## Summary:

The purpose of the visit to True Food in Santa Monica was to address hood capture issues.

**VERTICAL ISOMETRIC SKETCH  
OF MALL GREASE DUCTWORK**

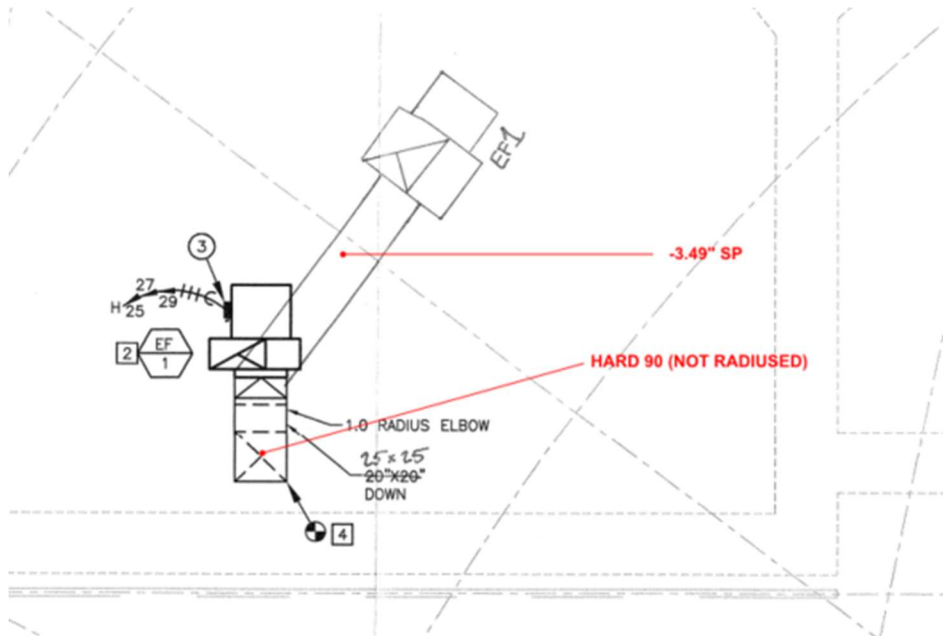
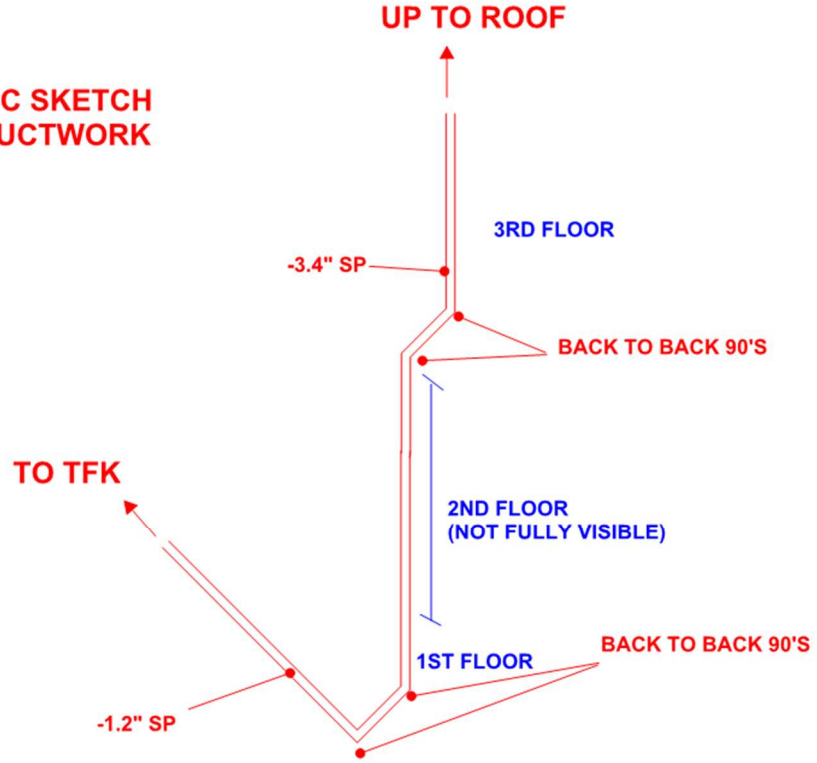
The remaining accessible exhaust duct run was inspected except for the second floor section of ductwork. Not all transitions are visible, but it appears there are between 6 to 8 transitions in the ductwork. There is also about a half of an inch of grease build up at one of the 90 degree transitions outside of True Foods. (see photos and sketches on the following pages).

1. The main hood EF is 4144 CFM out of original design of 6400 CFM. The airflow is low primarily due to pressure losses from multiple 90 degree transitions (some back to back) and system effect losses. A new larger fan will likely be required, however the pressure would have to double based on fan law to achieve the original design (7" @ 6400 CFM). This pressure may not be realistic. Also the more you increase velocity in the duct, the higher the impact due to system losses is. This means that airflow may not increase as much as predicted due to these transitions. Either way, it looks like a larger fan is needed. But there may be a need to have some of the ductwork modified if we cannot overcome the back to back 90 degree transitions to get optimum performance. Recommend consulting an OEM to discuss options.

Roof top grease duct/exhaust fan:

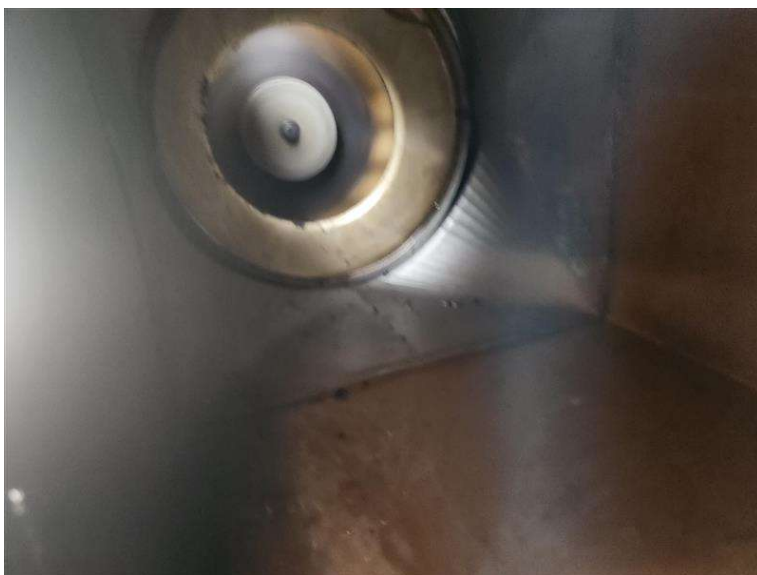
Fan inlet is clear and unrestricted
